S.I. No. M20-44A

SUBJECT: RUDDER AND ELEVATOR AFT BELLCRANK MODIFICATION

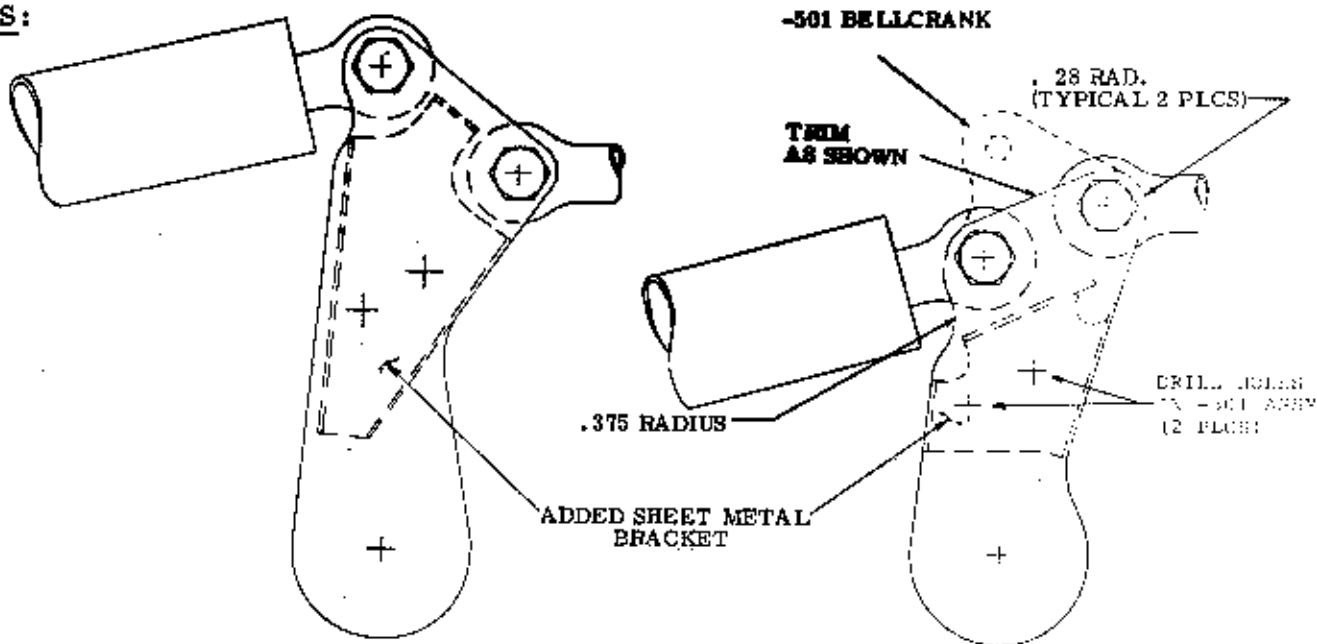
It is recommended that the bellcranks be updated to the 913030-503 and 913031-503 configurations at such time as there is reason to disassemble any of the control tube rod end bearings from the bellcranks. See Figure for modification of earlier bellcrank prior to adding bracket.

When it is determined necessary to disassemble the push-pull tube from either the rudder or elevator bellcrank it is recommended that the bellcrank be removed from the aircraft and modified per the attached drawing prior to reassembly of the push-pull tube to the bellcrank.

The simple sheet metal bracket is to be secured with two Avex rivets through existing holes in each bellcrank.

The modified bellcranks are to be reinstalled into the aircraft and are now ready for the reassembly of the push-pull tubes. The modification will allow the rod end bearing to fall only far enough to keep the bolt from being inserted if not aligned properly.

Reidentify each bellcrank after modification to XXXXX-503 part numbers and make entry into Aircraft Log Book when S.I. has been complied with.
